Review of Environmental Factors Addendum

Site environmental management works, Camellia – revised raised area and eastern retaining wall

Figure 1-1 Indicative retaining wall cross-section

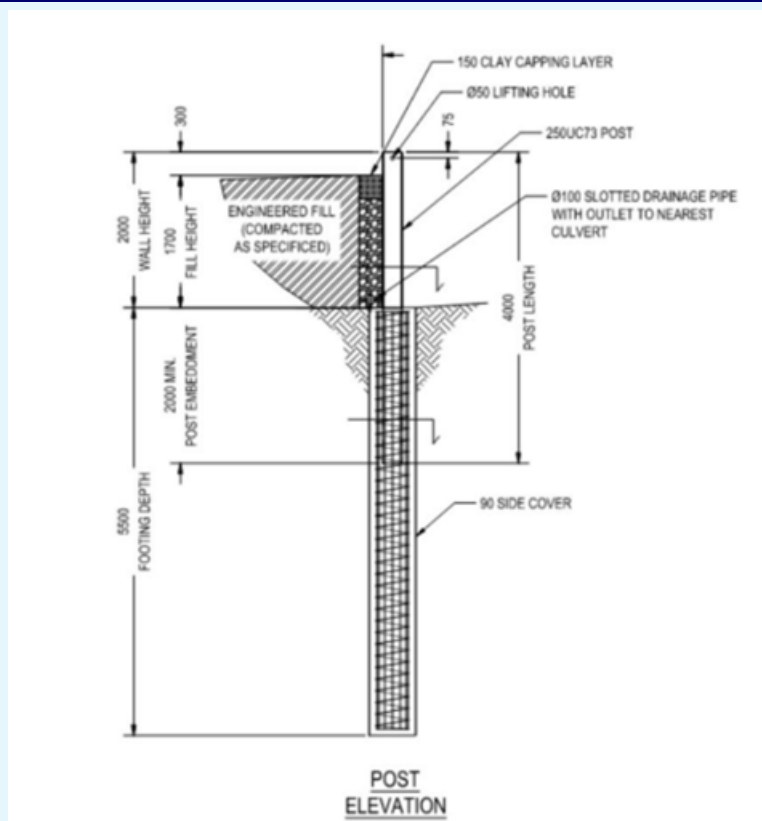
Aspect	Relevance to proposal
	The revised capping area would change the way surface water is stored and managed on site. The approved REF proposed to: • initially retain the existing retention basins on the site for surface water management • progressively infill existing retention basins as capping works progressed. Under this REFA, surface water would be stored in several new retention basins. The retention basins would be within and form part of the revised capping layer and would collect surface water. Once collected, surface water would be directed into the stormwater network and Duck River via the existing drainage channel. The retention basins would be in use until future planning approvals are obtained for the site. Retaining wall The retaining wall along the eastern boundary of the site would be about 400 metres in length and consist of both panels and posts. The panels would either be delivered to site on heavy vehicles or constructed in-situ. The retaining wall would be supported by piles about 600mm in diameter and between four to five metres deep. Piles would be spaced around 2.4 metres apart. The retaining wall would be setback about 100mm from the site boundary to enable the structure to be constructed wholly within the property. The area between the retaining wall and neighbouring property would remain as open space. Weed management controls such as grass planting would be implemented. Concrete trucks would deliver concrete for support posts. A small crane may be required to lift materials into place. Construction of the retaining wall is expected to take around 3 months and would occur simultaneous to the site capping works. Spoil from construction of the retaining wall has the potential to contain residual contamination. About 250m³ of spoil would be excavated. Spoil would be stored in temporary stockpiles within the site during construction and would be managed in accordance with a Construction Environmental Management Plan (CEMP). Figure 1-1 shows an example of a typical retaining wall cross-section.

Figure 4-1 PMF with sea level rise (approved REF)

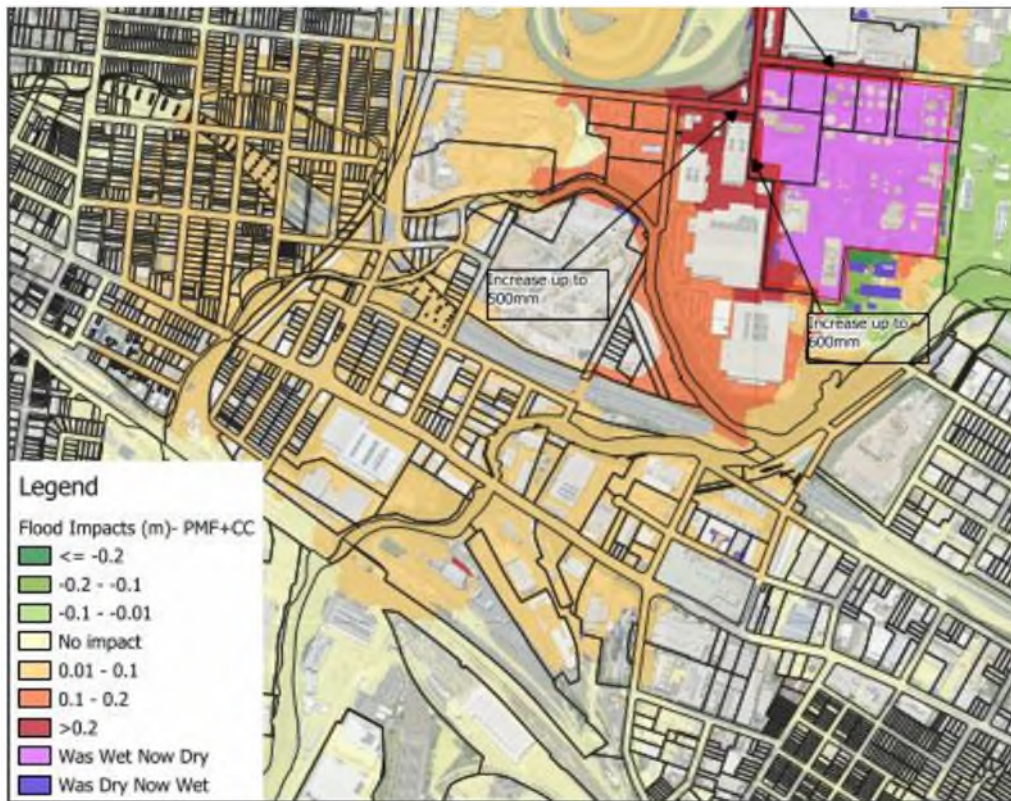
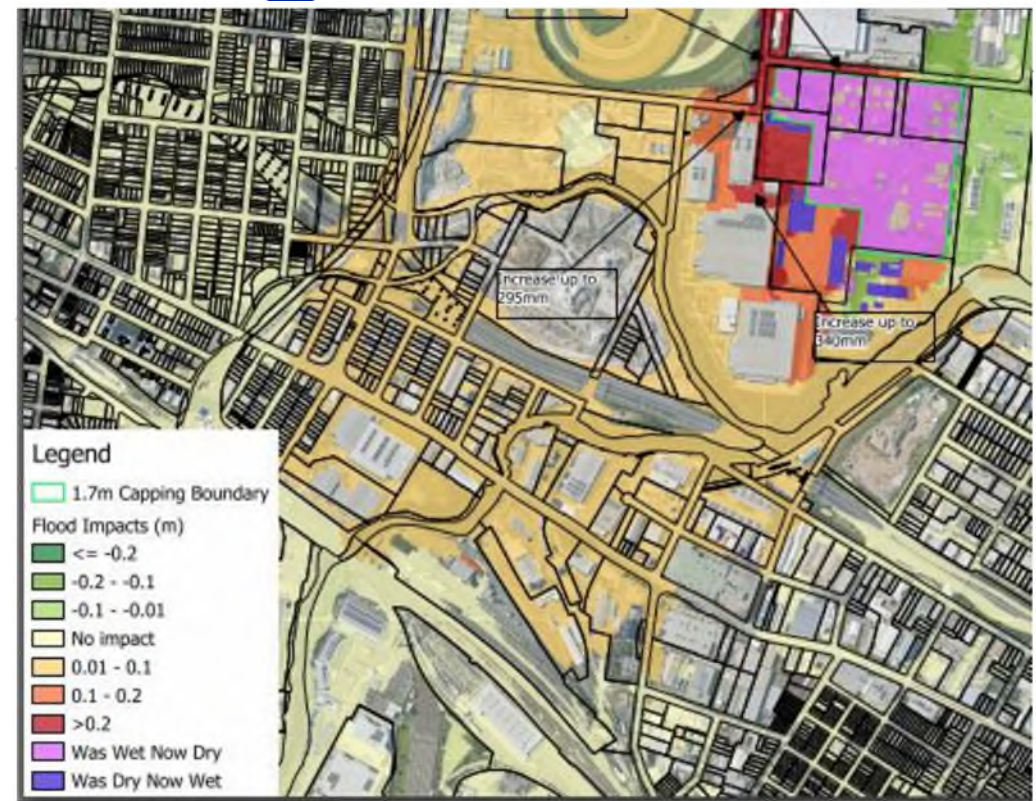
The assessment of PMF risk found that the revised capping design would still generate some flooding impacts for the Sydney Metro West Clyde site. Despite this, the revised capping design would decrease the PMF impacts to the Sydney Metro West site from what was modelled for the approved REF. The modelling for the revised design showed that during a PMF event (with climate change), flood levels would remain below the Sydney Metro West flood protection levels. The revised capping design would not pose a significant risk to human safety, infrastructure or the environment during a PMF event.

The revised capping design would reduce PMF impacts at Unwin Street, as shown in Figure 4-1 and Figure 4-2.
